## ADDENDUM NO. 1

### BEAL SLOUGH, S. 56TH AND OLD CHENEY WETLAND PROJECT #702233 Specification No. 08-041 February 6, 2008

3. Refer to Plan Sheet 5; Bottom Excavation Grading Plan:

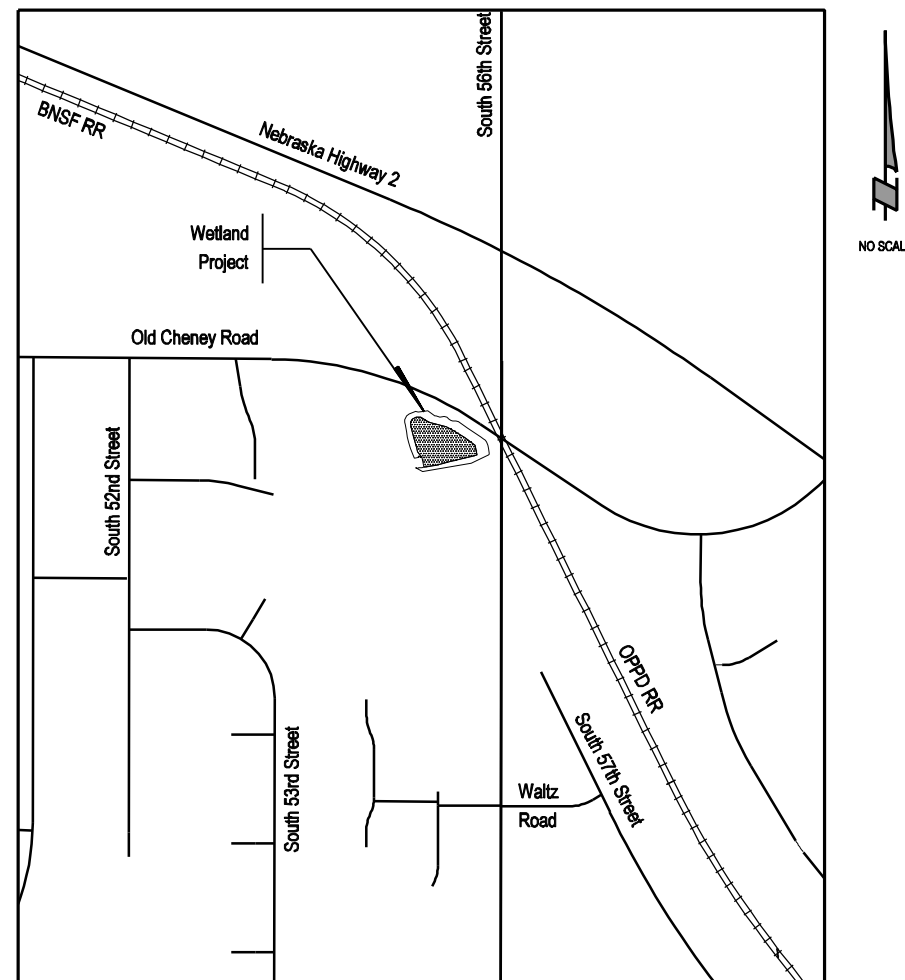
Note that the lowest elevation in the wetland area shall be 1221.50 rather than 1221.00.
